CHATHAM COUNTY PURCHASING DEPARTMENT

ADDENDUM NO. 1 TO BID NO. 16-0119-4

FOR: TIDE GATE MONITORING AT PIPEMAKERS CANAL

PROJECT	TIDEGATE MONITORING PIPEMAKERS CANAL, CHATHAM CO. GA	NUMBER	1	LOCATION	CHATHAM COUNTY, GEORGIA
SHEET	SK-1	DESIGNED	C.COBB 01/30/2017	CHECKED	C.COBB 01/30/2017

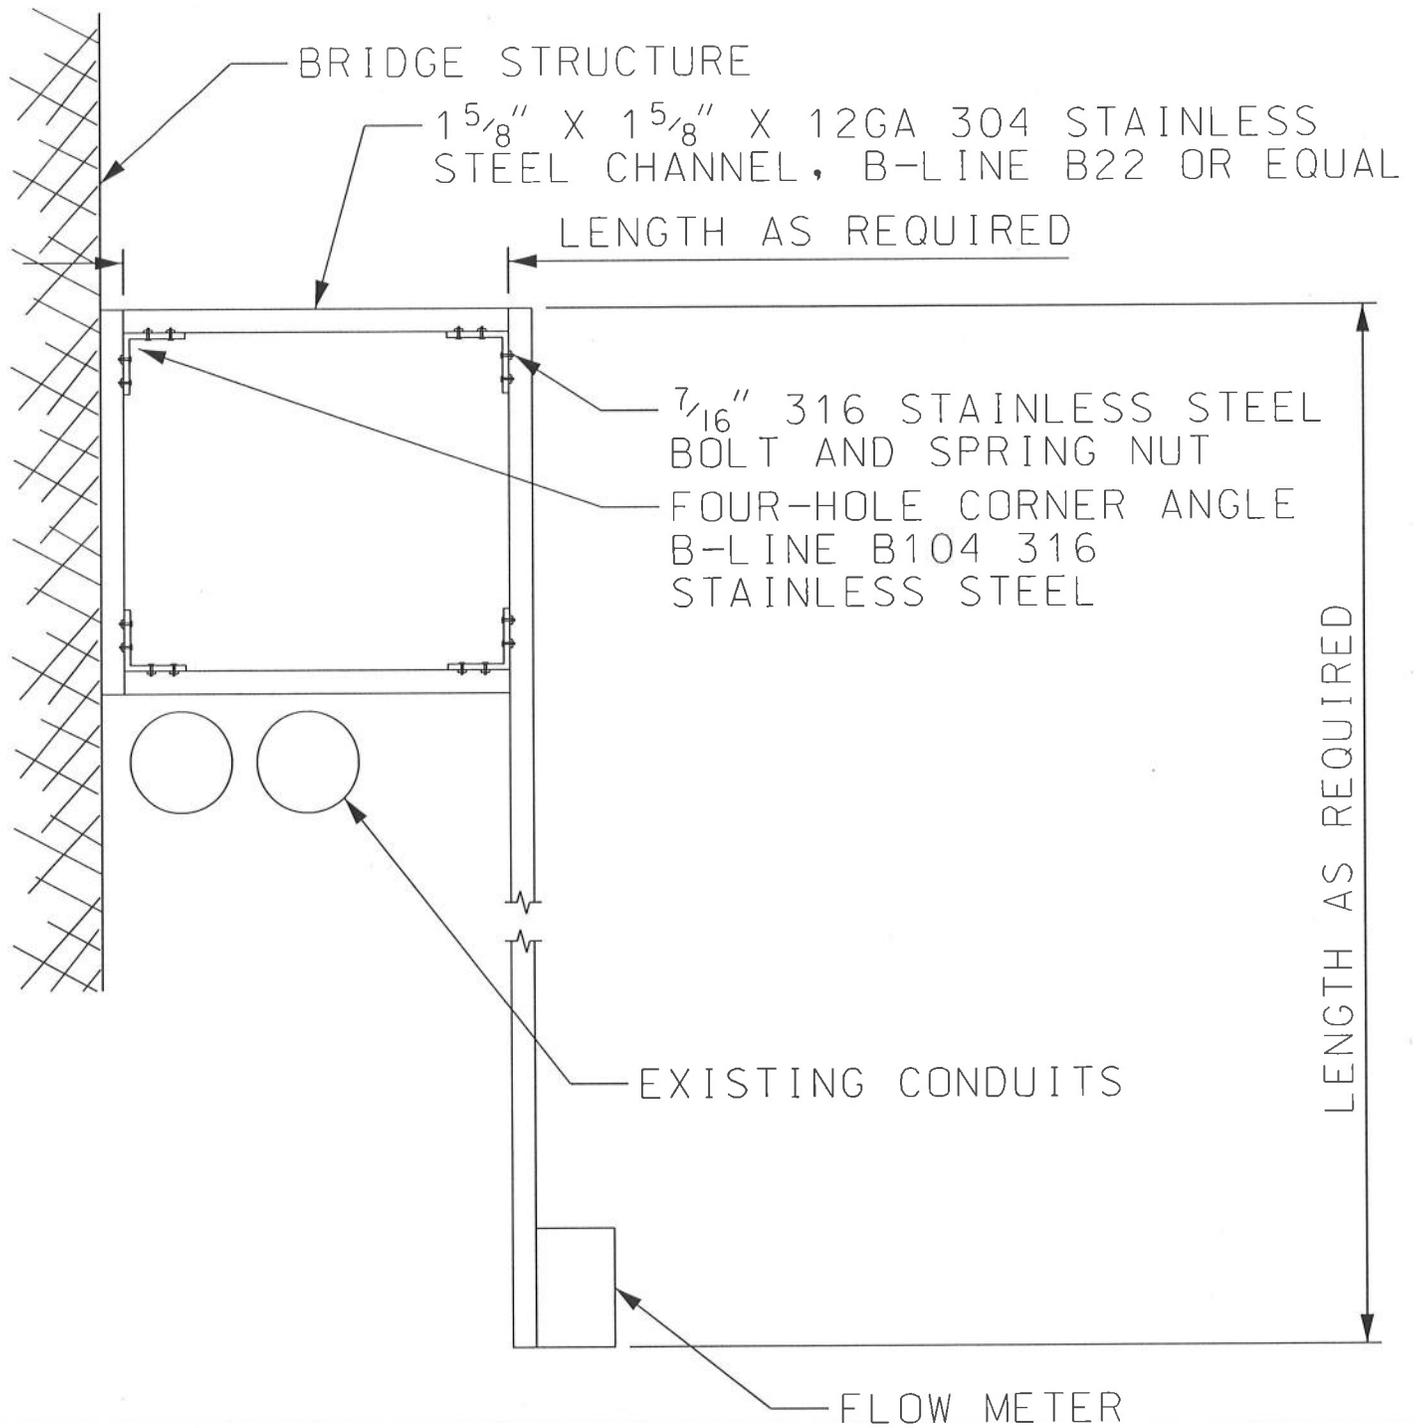
1. Detail 3/e2 indicates bracket and framing to 'hold off' the uni-strut and flow meter from the bridge. The detail indicates to utilize SS strut vertically to mount the meter in the stream. However, we cannot locate a detail or information regarding the structure that extends out away from the bridge and over the existing conduits. Please provide a detail for this structural frame.

**Answer: See attached Plan Sheet SK-1**
